AMENDMENT NO. 2 SEPTEMBER 2024

**IS 16192 (PART 3) : 2018 AUTOMOTIVE VEHICLES — WHEEL RIMS FOR TWO AND THREE WHEELED VEHICLES**

**PART 3 SPOKE WHEEL RIMS — METHODS OF TESTS AND REQUIREMENTS**

FIG. 1 LOAD APPLYING METHOD'

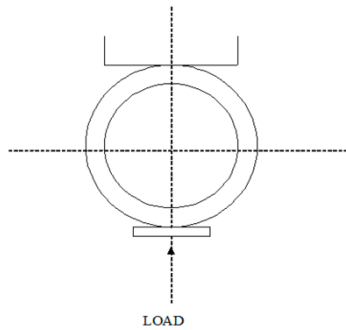
(Page 1, clause 4.2) — Substitute the following for the existing:

Place the rim vertically on the base having a plane of not smaller than a horizontal rim width and add the load gradually, as per Fig. 1 to the rim, toward the direction of vertical centre of rim from the most outside circumference part of rim.

**4.2.2.1** When the deflection of wheel rims (without wired spokes) has attained a value given in Table 1 by applying a load by the method given in Fig. 1 to the rim, the load shall not be smaller than the value given in Table 2 and in addition, the rim shall be free from cracks.

**4.2.2.2** For the sizes not available in Table 1 and Table 2, when the deflection of wheel rims (without wired spokes) has attained a value as declared by wheel rim manufacturer, applying a load by the method given **4.2.1** to the rim, the load shall not be smaller than the value declared by wheel rim manufacturer and in addition, the rim shall be free from cracks.

FIG. 2 CYLINDRICAL BEAD SEAT RIM CONTOURS

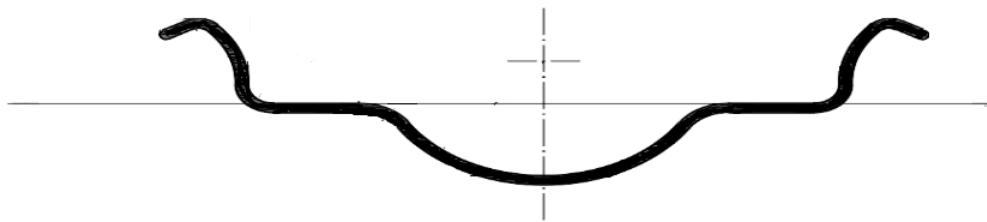
(Page 2, clause 4) — Insert the following after 4 and renumber the subsequent clauses

A rim contour for cylindrical bead seat rim is given at Fig. 2.

FIG. 3 5° TAPERED BEAD SEAT RIM CONTOURS (MT TYPE)

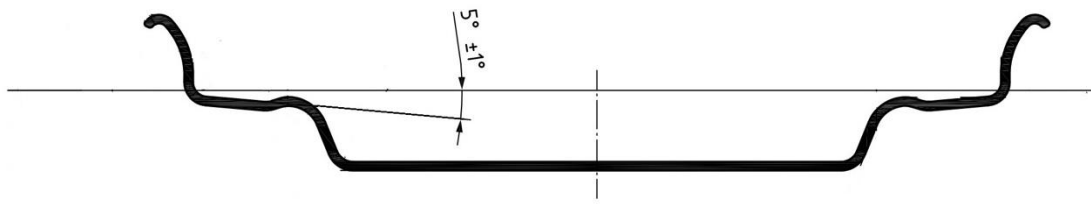
5.2.1 Rim contour for 5° tapered bead seat rim with hump is given in Fig. 3, rim contour for tapered bead seat rim with hump and well contour is given in Fig. 4 and rim contour for tapered bead seat rim without hump is given at Fig. 5.

FIG. 5 TAPERED BEAD SEAT CONTOURS FOR RIMS WITHOUT HUMPS

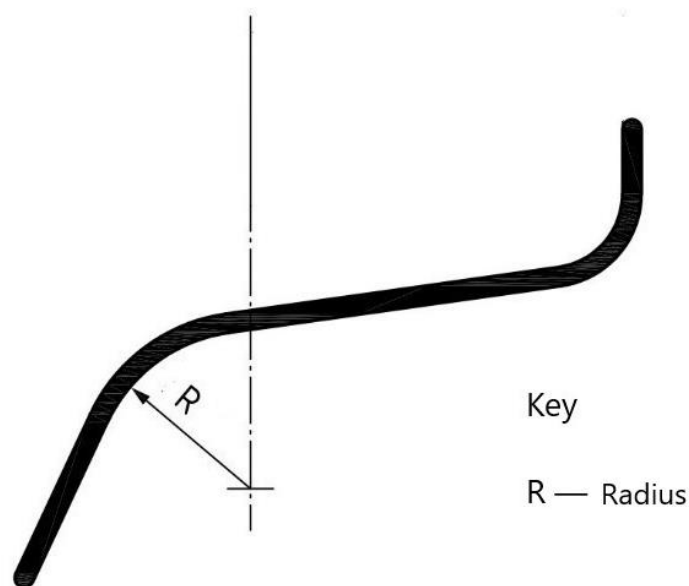
5.2.2 Rims without hump shall only be used with tyres for tube type application.
